The following text is proposed to be inserted in Preliminary Draft New Recommendation ITU-R F.[9B/BWA], “Radio interface standards for broadband wireless access systems in the fixed service operating below 66 GHz” (Annex 6 to ITU-R Document 9B/83):

FIGURE 1

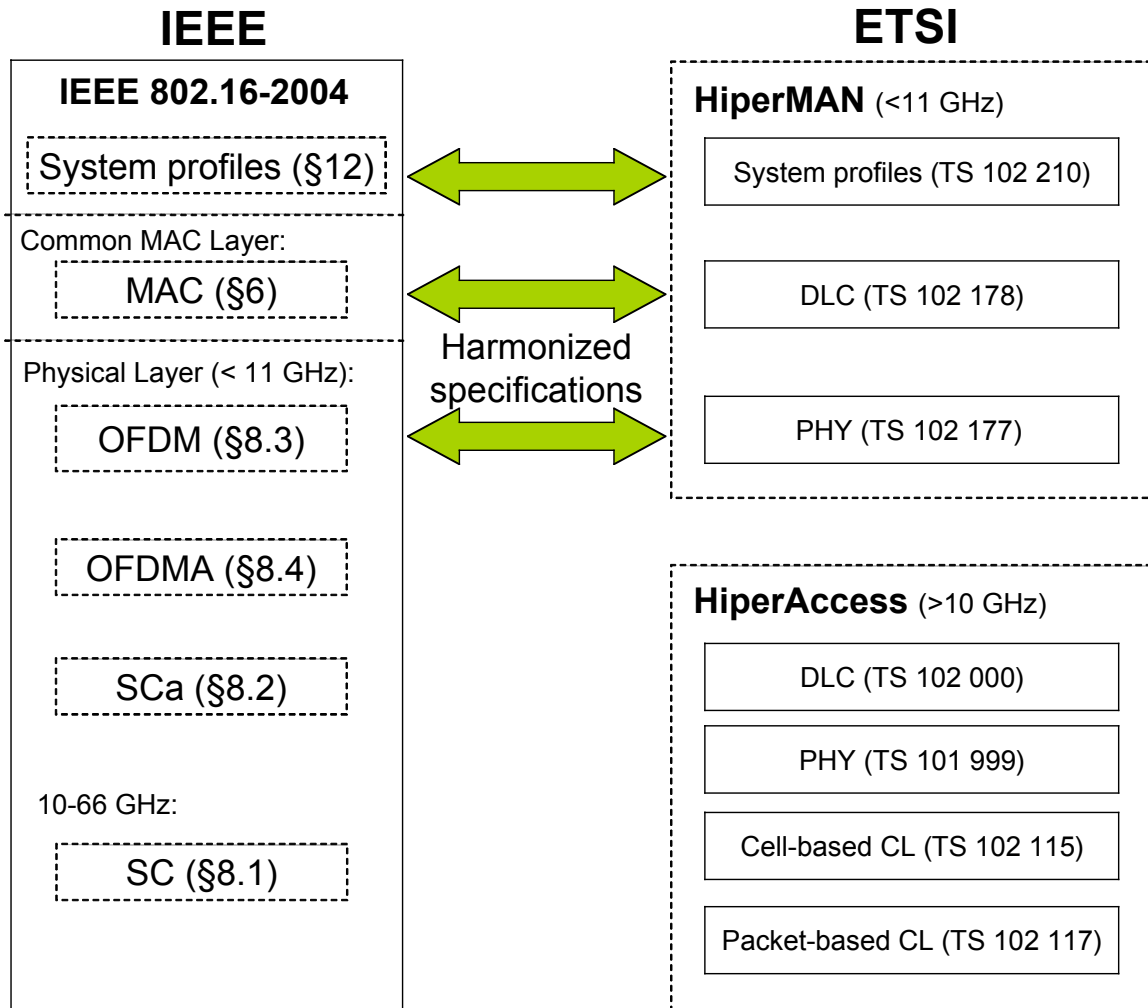
Figure 1 shows the equivalency of the IEEE 802.16-2004 and ETSI HiperMAN standards. Since the standards contain options to fulfill the needs in multiple environments, the first step towards interoperability is the definition of system profiles.
